S T E W A R T

RECOMMENDATION MEETING

800 Stewart St, Seattle, WA

SDCI#3034006-EG

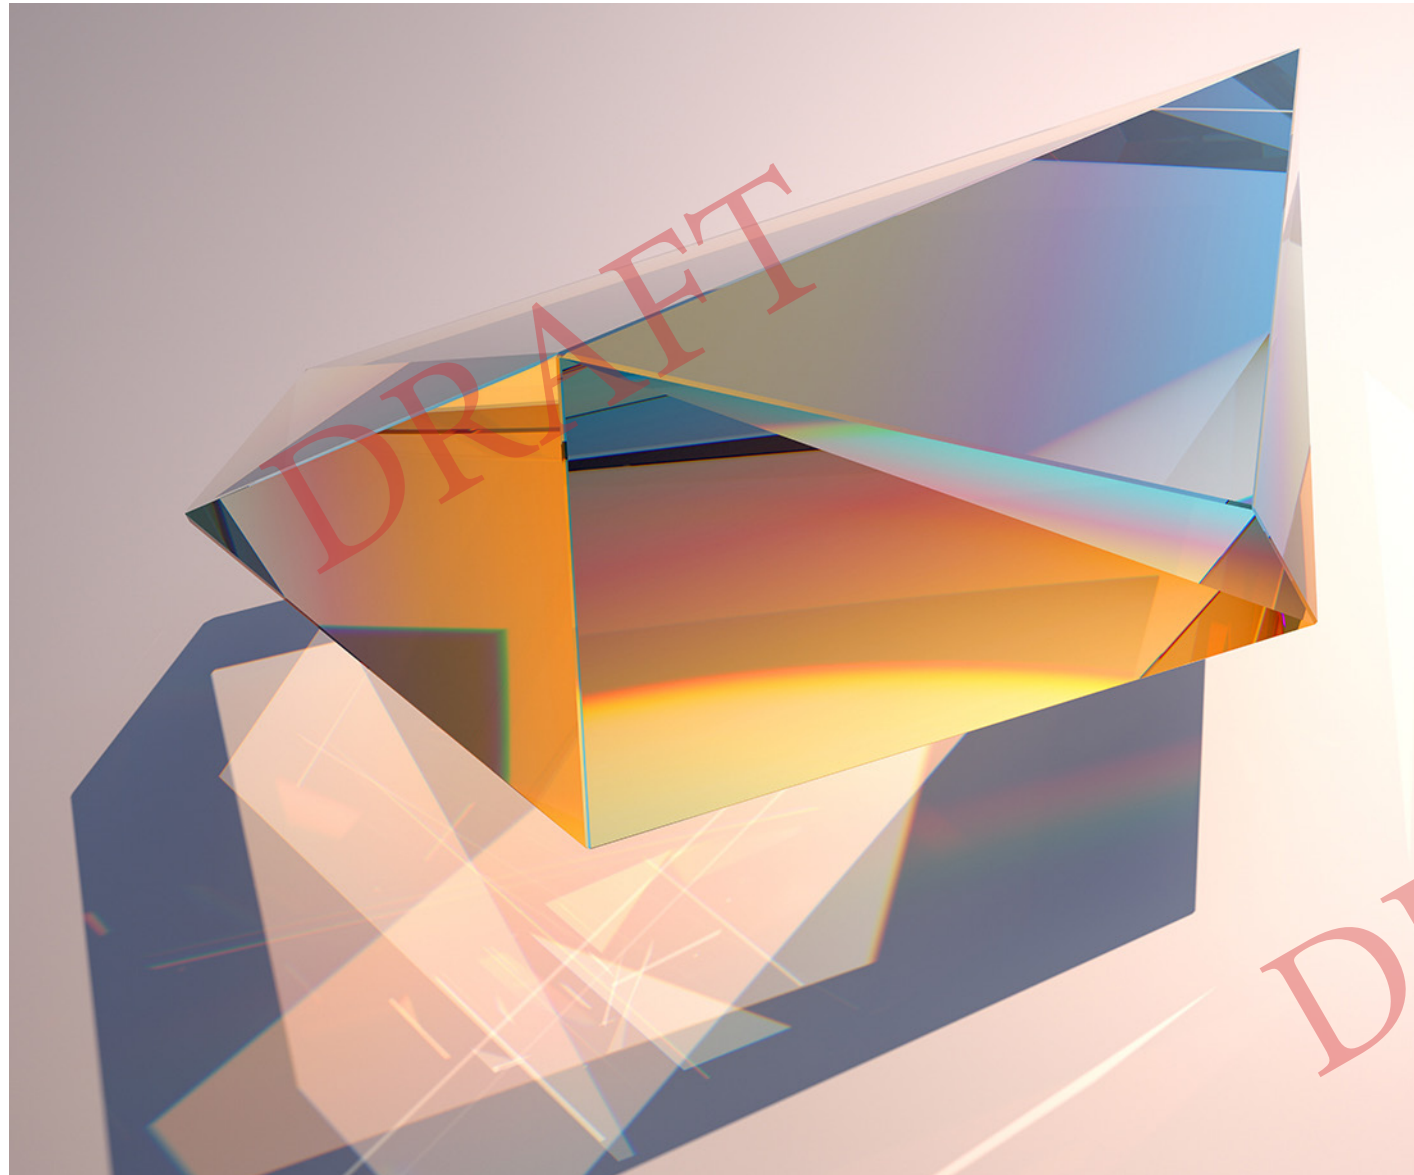
- 1 a.** The Board continued to support the applicant's preferred scheme agreeing that it had the most potential to appropriately respond to context and enhance the skyline. (B-1, A-2)
- 2 a.** The Board agreed that the "Refract" design concept had evolved positively since the first EDG meeting and provided guidance to explore further enhancements that would strengthen its expression. (A-2, A-1, B-4)
- 2 b.i.** The Board agreed that this strengthening could occur in a number of ways and asked the design team to specifically explore the following possibilities:
 - Establishing a baseline exterior expression for the pure rectangular form of the tower with a distinctly different expression for the refracted elements. (A-2, B-1)

The design team has refined the expression of the two primary façade languages that correspond to the refracted portions of the tower massing. The rectilinear façade language includes the angled curtain wall panel pattern (and integrated lighting) with a subtly blue-grey glazing. The refracted portions of the tower are absolutely minimally fenestrated with minimal butt-glazing and a low iron, ultra-clear but high performance glazing. The third façade language includes the white precast concrete panel with angled panels that wraps the North and East portions of the podium.

RI PLAN - SHOW OVERHEAD DASHED

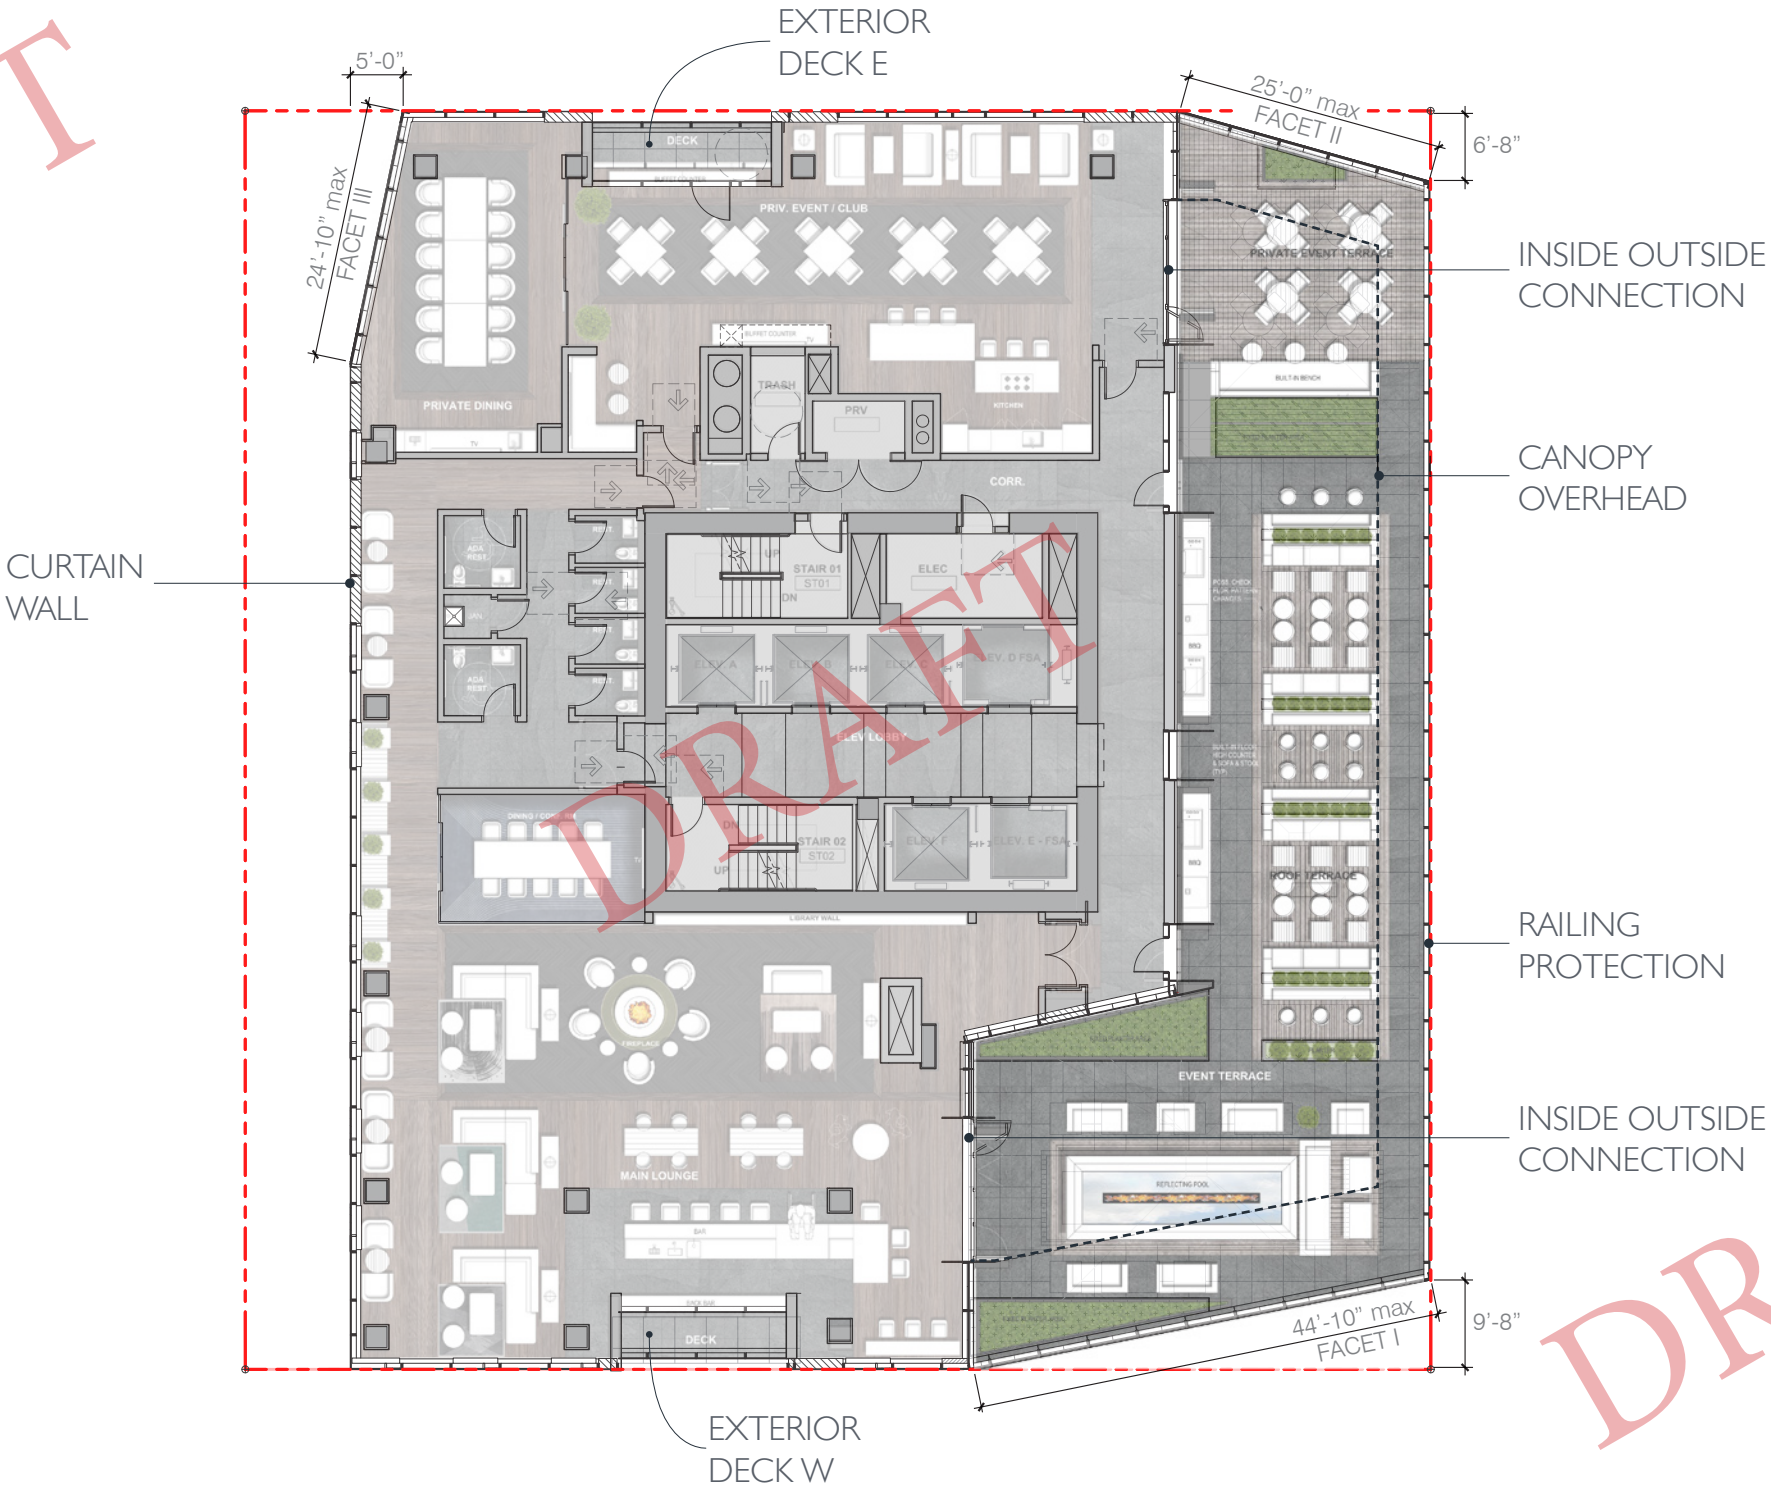
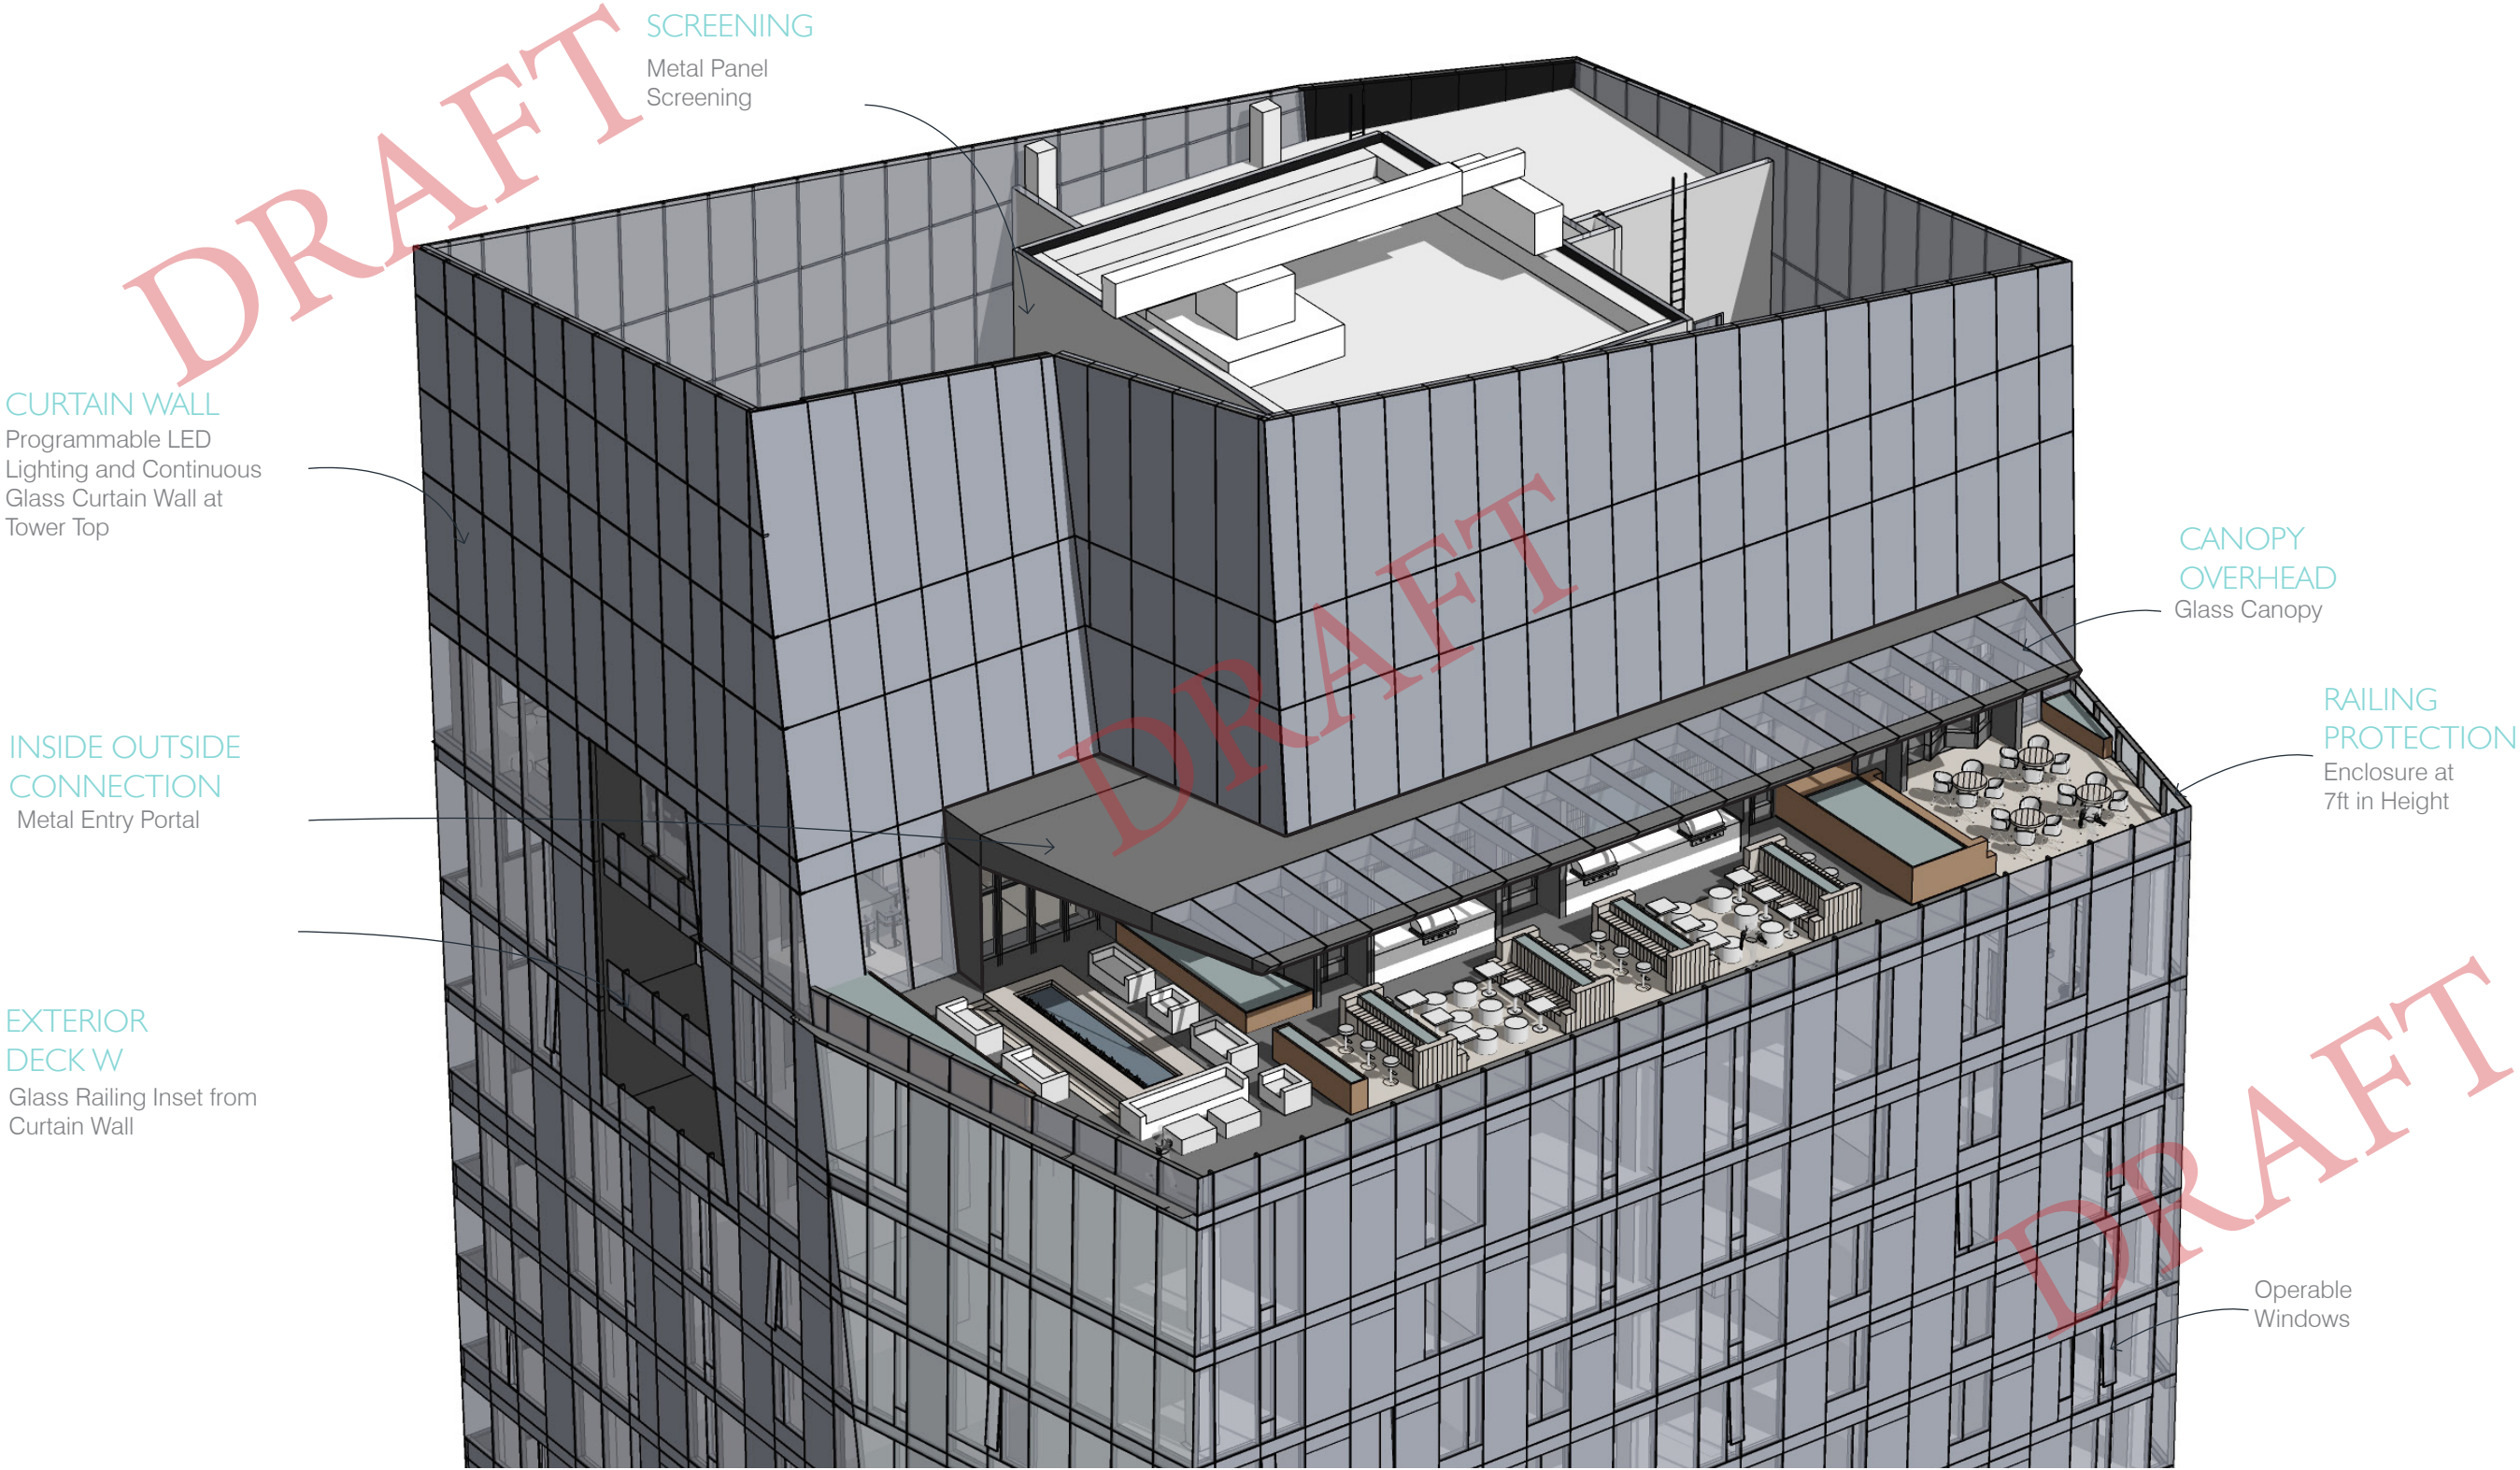
2 b.ii. The Board agreed that this strengthening could occur in a number of ways and asked the design team to specifically explore the following possibilities:

Exploration of the use of color to highlight and strengthen the expression of the two punched openings at the top of the tower. Ideally this development would be tied to that of the proposed programmable strip LED lighting. (B-4, A-1)

3 a. The Board agreed that the top of the tower did not yet seem to be tied to the overall design concept and directed the design team to explore further options in the articulation of the canopy, the parapet condition and the mechanical screening. (B-4)

3 b. The Board agreed that a more deliberate articulation of these elements would be required to create a unified architectural expression. (B-4)

The design team has taken a holistic approach to refining the top of the tower. The integration of the various elements including the RI canopy, mechanical screening, outdoor landscape area, exterior walls, and materiality have been modified in order to bring a more resolved and elegant tower top that is cohesive with the design language of the rest of the project.

The design team continues to refine the design and details at the tower top. The glass canopy is re-proportioned to provide appropriate weather protection. The railings at the roof terrace are heightened to provide protection from strong winds and discomfort.
